UNITED STATES PATENT AND TRADEMARK OFFICE

APPLICATION NO.	FILING DATE	FIRST NAMED INVENTOR	ATTORNEY DOCKET NO.	CONFIRMATION NO.
10/813,049	03/31/2004	Robert Ames	4548-002	4862

Office Action Summary

Claims 1-5 are rejected under 35 U.S.C. 102(b) as being anticipated by Anderson (U.S. Patent 5,913,670) (see marked-up figure below).

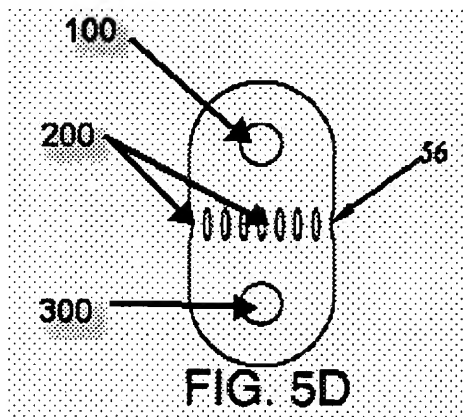
Claim 1. Anderson discloses (fig.5d) a breakaway connector, comprising: first connecting means (100) for connecting with an external device; and second connecting means (200, 300) for maintaining a length of rope in a bent state and for holding the rope until a load applied to the rope reaches a predetermined level at which said second connecting means completely release

the rope, said second connecting means comprising a breakaway element (200) that will fail under said load of said predetermined level to release the rope.

Claim 4. Anderson discloses the breakaway connector of claim 1, wherein said second connecting means further comprise guiding means (56) for guiding the rope around said breakaway element to define a bent section of the rope at said breakaway element and first and second sections of the rope on opposite sides of the bent section.

Claim 5. Anderson discloses the breakaway connector of claim 4, wherein said guiding means comprise a passage (passage of 56) and said breakaway element is positioned in said passage to divide said passage into first (left most channel of 56) and second channels (right most channel of 56) for accommodating the first and second sections of the rope, respectively.
